Access Compliance Report

Public Rights-of-Way

(Pedestrian Signals)

Intersection ID: N/A	Main Street:	Cross Street: N/A	Location: N/A
ADA ID: 3FCC3E183213	Signal Type: One Push Button-Non APS	Overall Compliance: No	Severity Score: BTN 1: N/A BTN 2: N/A No BTN: N/A
Codes/Mitigation Info/Possible Solution		Field Measurements/Component Compliance

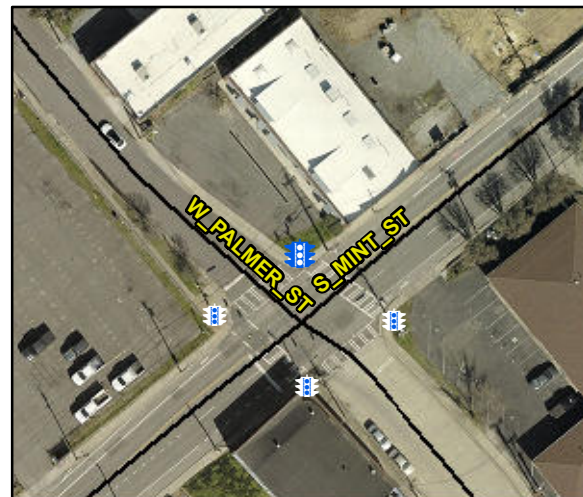
Surveyor Notes: N/A

Compliance	Description	Data	Compliance	Description	Data
	Button Count	Button1	N/A	Distant to Additional Button (in)	N/A
	Additional Button Present?	No		Additional Button ID	N/A
N/A	Signal Buttons Required?	N/A	N/A	Additional Ped Posts Required	N/A
	How Many Ped Street Xings?	2		Located In An Island/Median?	No
N/A	B 1 Sign Present?	Yes	N/A	B 2 Sign Present?	N/A
Yes	B 1 Sign Purpose?	Yes	N/A	B 2 Sign Purpose?	N/A
Yes	B 1 Sign Lettering & Contrast?	Yes	N/A	B 2 Sign Lettering & Contrast?	N/A
Yes	B 1 Parallel To XWalk?	Yes	N/A	B 2 Parallel To XWalk?	N/A
Yes	B 1 PAR to Button?	Yes	N/A	B 2 PAR to Button?	N/A
Yes	B 1 PAR to XWalk?	Yes	N/A	B 2 PAR to XWalk?	N/A
Yes	B 1 Clear Floor Space?	Yes	N/A	B 2 Clear Floor Space?	N/A
N/A	B 1 FWD Approach?	Yes	N/A	B 2 FWD Approach?	N/A
N/A	B 1 FWD Approach Constrained?	No	N/A	B 2 FWD Approach Constrained?	N/A
No	B 1 FWD Approach Reach (in)	6.0	N/A	B 2 FWD Approach Reach (in)	N/A

N/A	B 1 FWD Approach Width (in)	N/A	N/A	B 2 FWD Approach Width (in)	N/A
N/A	B 1 FWD Approach Obstruction?	Yes	N/A	B 2 FWD Approach Obstruction?	N/A
N/A	B 1 FWD Approach Obstruction Dist (in)	4.0	N/A	B 2 FWD Approach ObstructionDist (in)	N/A
N/A	B 1 PARA Approach?	Yes	N/A	B 2 PARA Approach?	N/A
N/A	B 1 PARA Approach Constrained?	No	N/A	B 2 PARA Approach Constrained?	N/A
Yes	B 1 PARA Approach Reach (in)	6.0	N/A	B 2 PARA Approach Reach (in)	N/A
N/A	B 1 PARA Approach Width (in)	N/A	N/A	B 2 PARA Approach Width (in)	N/A
N/A	B 1 PARA Approach Obstruction?	Yes	N/A	B 2 PARA Approach Obstruction?	N/A
N/A	B 1 PARA Approach Obstruction Dist (in)	4.0	N/A	B 2 PARA Approach ObstructionDist (in)	N/A
No	B 1 Clear Floor Space Slope (%)	10.7	N/A	B 2 Clear Floor Space Slope (%)	N/A
No	B 1 Clear Floor Space XSlope (%)	6.7	N/A	B 2 Clear Floor Space XSlope (%)	N/A
N/A	B 1 PAR Slope (%)	5.2	N/A	B 2 PAR Slope (%)	N/A
Yes	B 1 Height (in)	41.0	N/A	B 2 Height (in)	N/A

Yes	B 1 Pressure (#)	1.0	N/A	B 2 Pressure (#)	N/A
No	B 1 Closed Fist Operation?	No	N/A	B 2 Closed Fist Operation?	N/A

Yes	B 1 Clear Xing Direction?	ClearlyMarked	N/A	B 2 Clear Xing Direction?	N/A
	B 1 Crossing Direction	To SE		B 2 Crossing Direction	N/A
Yes	B 1 DistanceTo XWalk (in)	0.0	N/A	B 2 DistanceTo XWalk (in)	N/A
No	B 1 DistanceTo Curb (in)	84.0	N/A	B 2 DistanceTo Curb (in)	N/A
Yes	B 1 Diameter (in)	2.0	N/A	B 2 Diameter (in)	N/A

Possible Solutions: Replace Signal Push Button With APS Button on New Post. Remove & Relocate Sign.
